Subject: Docket No. 50-482: License Amendment Request – Revision to
Technical Specification 3.3.2, “Engineered Safety Feature
Actuation System (ESFAS) Instrumentation”

**Subject: License Amendment Request – Revision to Technical Specification 3.3.2,
“Engineered Safety Feature Actuation System (ESFAS) Instrumentation”**

EVALUATION OF PROPOSED CHANGE

ACTIONS (continued)

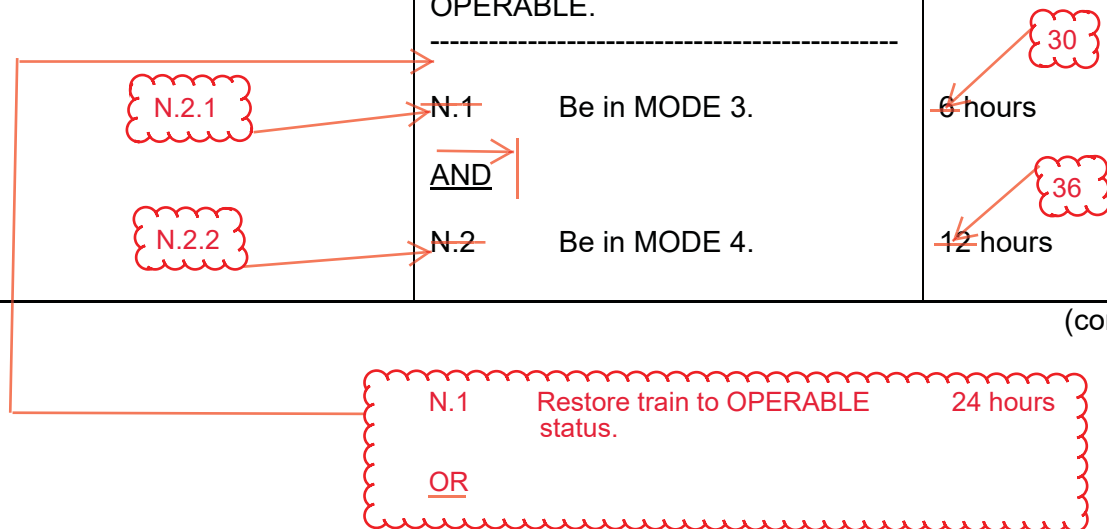
CONDITION	REQUIRED ACTION	COMPLETION TIME
L. One or more required channel(s) inoperable.	L.1 Verify interlock is in required state for existing unit condition.	1 hour
	<u>OR</u>	
	L.2.1 Be in MODE 3.	7 hours
	<u>AND</u>	
	L.2.2 Be in MODE 4.	13 hours
M. One channel inoperable.	M.1 Place channel in trip.	1 hour
	<u>AND</u>	
	M.2 Restore channel to OPERABLE status.	During performance of next COT
N. One train inoperable.	-----NOTE----- One train may be bypassed for up to 2 hours for surveillance testing provided the other train is OPERABLE. -----	
	N.1 Be in MODE 3.	6 hours
	<u>AND</u>	
	N.2 Be in MODE 4.	12 hours
